## QUALITY VALIDATION (QV) REPORT

### Red Hill Bulk Fuel Storage Facility Defuel

Subject: Recommended Repairs at Two Concrete Pipe Anchor Bulkheads Prior to Defueling (NDAA Deficiency Item Nos. PSC.44A and PSC.71A)

**Figure 2 –NDAA Deficiency Item PSC.44A (located next to Pipe Support [PS] 144)**

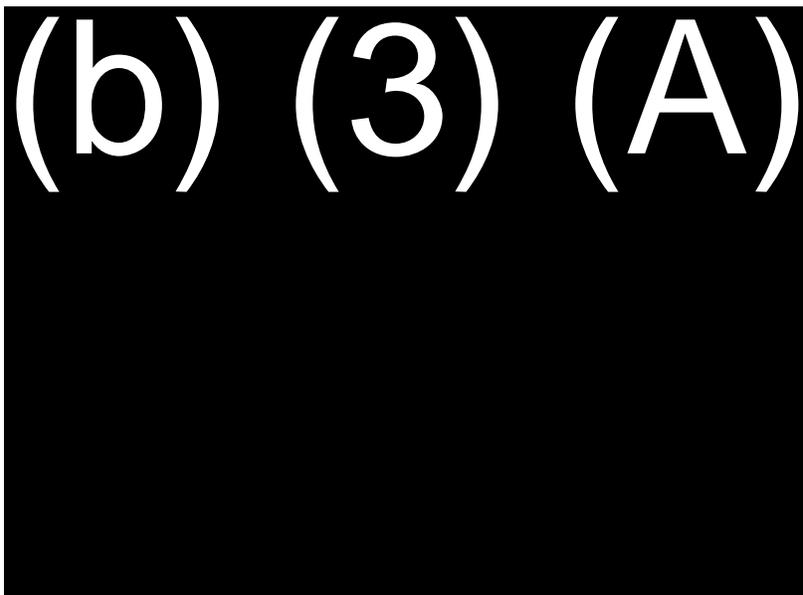
The diameters of both the F-24 and JP-5 pipes are reduced at PSC.44A (Figure 2), likely due to previous repairs. The reduced pipe sections are likely sleeved through the (b) (3) (A)

The sections of the (b) (3) (A) are reduced at PSC.44A, likely due to previous repairs. The reduced pipe sections are likely sleeved through th (b) (3) (A)

. Replacing the chipped concrete at this location will likely not be sufficient to reinstate the original design anchorage forces for the (b) (3) (A) unless the reduced sections are also anchored into the concrete.

SGH Memo 003 dated 30 NOV 22 determined the concrete repair is not necessary. No work was performed.
